On behalf of the Applicant, we herewith formally submit the consolidated technical compliance package in support of the Section 16 Planning Application (Application No. A/NE-LYT/881) for the proposed Temporary Private Car Park (34 spaces) at Lots in D.D. 83, Lung Yeuk Tau, Fanling. To facilitate efficient cross-departmental review by the Town Planning Board, Planning Department, Transport Department, Drainage Services Department, and Fire Services Department, all previously prepared technical schemes, layout options, and engineering assessments have been integrated into this Master Compliance Framework.

Proposed Temporary Private Vehicle Park (Private Cars Only)
for a Period of 3 Years in "Residential (Group C)" Zone,
Lots 807 S.E, 827 RP (Part) and 828 RP in D.D. 83, Lung Yeuk Tau, Fanling
Submission for Compliance with Approval Condition (a)
Submission of Revised Drainage Proposal

SUBMISSION REPORT
FOR
DRAINAGE PROPOSAL DESIGN
FOR TEMPORARY PRIVATE VEHICLE PARK (PRIVATE CARS ONLY)
FOR A PERIOD OF 3 YEARS
LOT 807 S.E, 827 RP (PART) AND 828 RP IN D.D.83
LUNG YEUK TAU, FANLING, N,T,

1 / 002 TYPICAL TURNING RADIUS
SCALE = 1:100

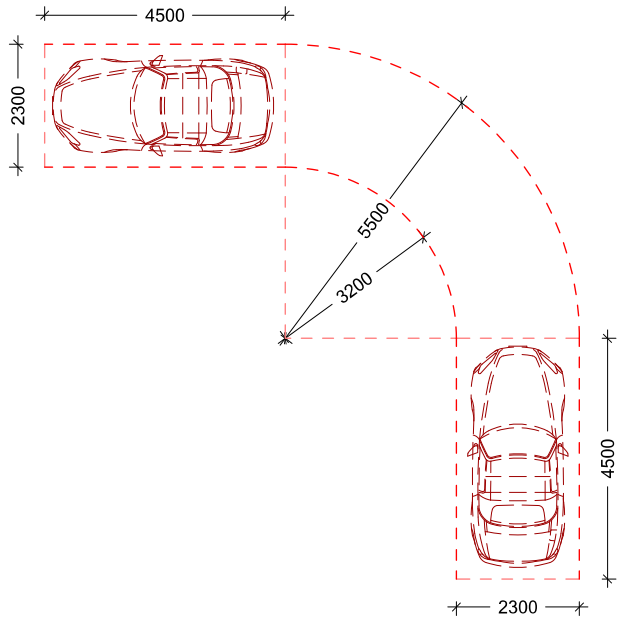
3. In the latest swept path analysis diagrams provided by the applicant, only the discrete positions of the vehicle were shown. Continuous profile of the outline of the vehicle should be shown along the whole path of travelling.

1/000 SITE PLAN: Access

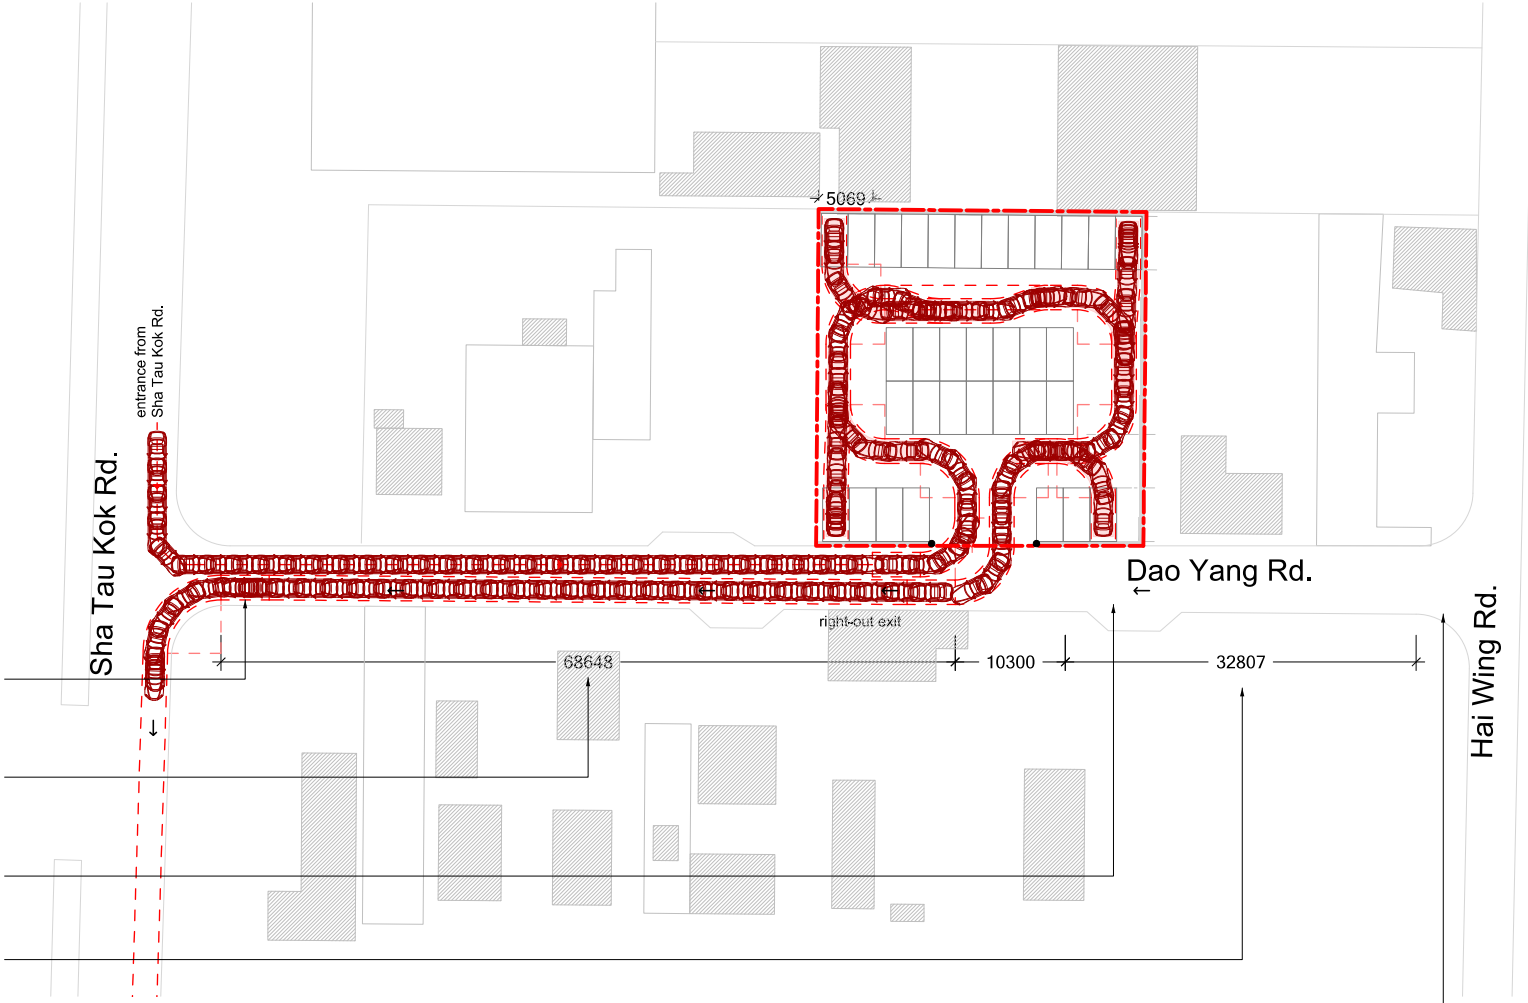
2. The applicant should include the existing traffic flow in calculating the v/c ratio of Dao Yang Road.

VOLUME-TO-CAPACITY RATIO < 0.65. REASONABLY UNIMPENDED OPERATIONS WITH LIGHT RESTRICTED MANEUVERABILITY.

VOLUME-TO-CAPACITY RATIO < 0.5. FREE-FLOW CONDITION. STOPPED DELAY AT INTERSECTION IS MINIMAL
